# **ROYAL RANDWICK RACECOURSE**

**ACCESS REVIEW**

**Morris-Goding Accessibility Consulting**

4<sup>th</sup> November 2011

The report has been reviewed in accordance with updated project number 21101 and drawings DA-07, DA-11 and DA-30 Issue 30 (please see attached supplied drawings below relevant to this report)

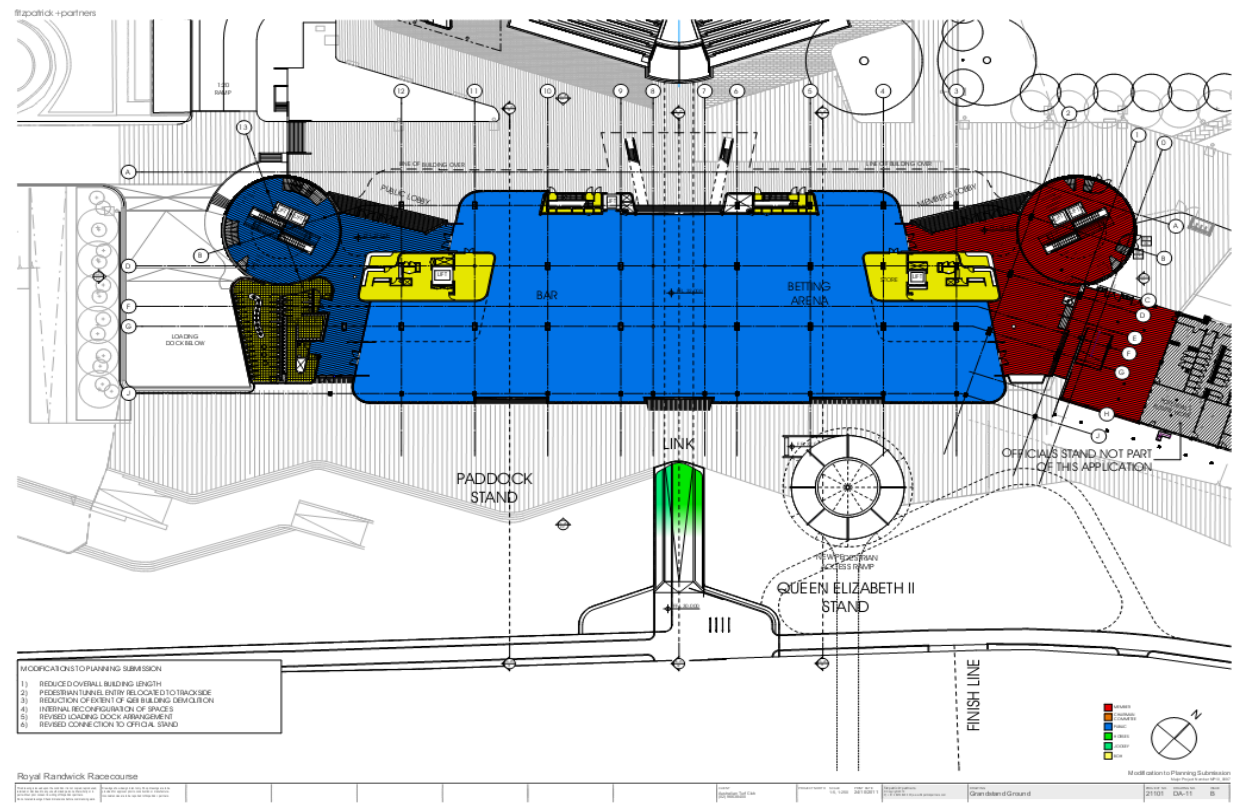
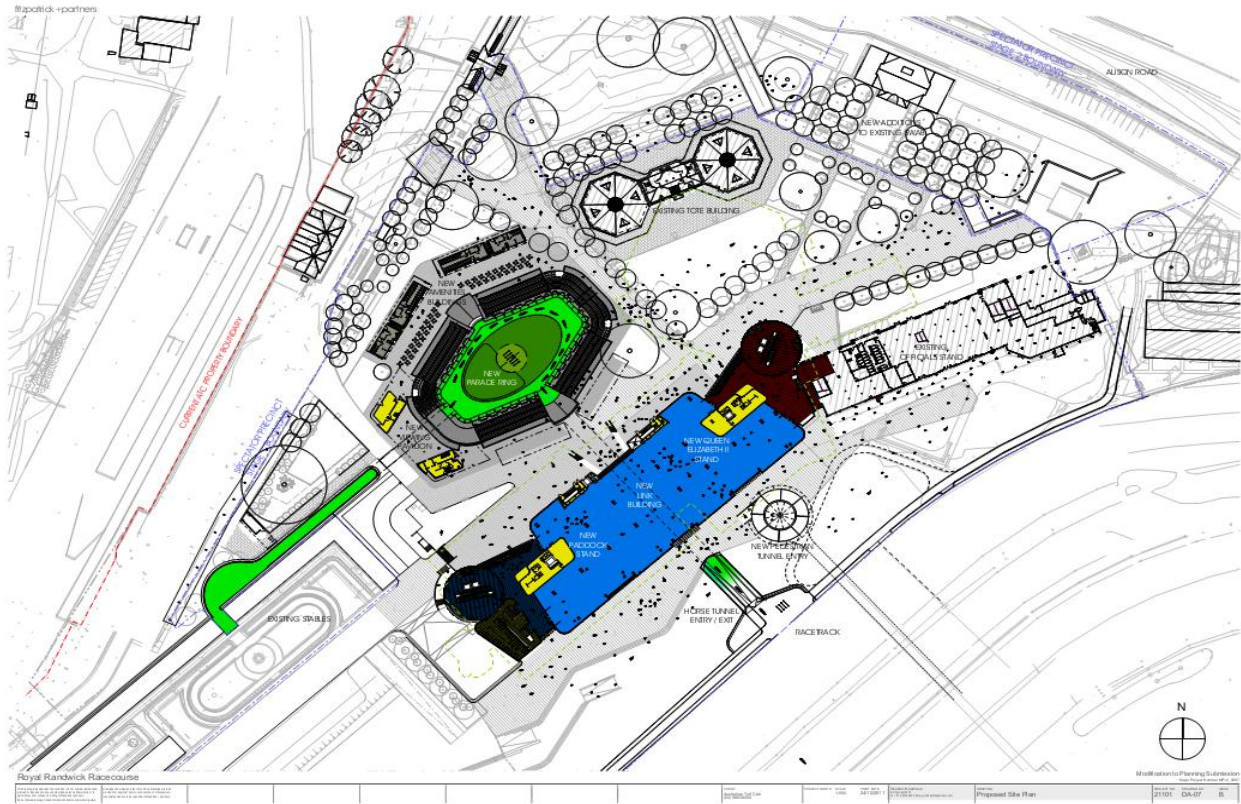
- (i) Ensure the accessible WC found on level 2 is approached from within the chairman lounge area corridor, rather than from the BOH (DDA issue).

- (i) Based on current 75W grandstand drawings DA-11 the south end accessible WC entry doors have a minimum clear open width of 850mm (920mm door leaf) compliant with AS1428.2 and BCA. It is presumed that all other accessible WC on all other floor will achieve the some open clear width as the ground floor accessible WC door (to be reviewed at a later stage).
- (ii) Based on current 75W grandstand drawings DA-11 the south end accessible WC, a minimum 2000mm x 1600mm un-obstruction circulation space is achieved around the toilet pan compliant with AS1428.1. It is presumed that all other accessible WC on all other floor will achieve the some clear circulation spaces, (to be reviewed at a later stage).

A minimum 2300mmn x 1900mm unobstructed circulation space around the toilet pan would be required should the client wish to comply with the DDA Premises Standards. In both instances the basin should not encroach into this area (may encroach max 100mm only).

From drawing DA-30, there are 4 banks of male and female toilets found towards the west of the Parade ring. Within each bank of toilets an accessible WC has also been provided. Currently the 4 unisex accessible WCs have a 2970mm x 1920mm internal dimension that would allow and appropriate 2000mm x 1600mm unobstructed circulation space around the toilet pan, compliant with AS1428.1.
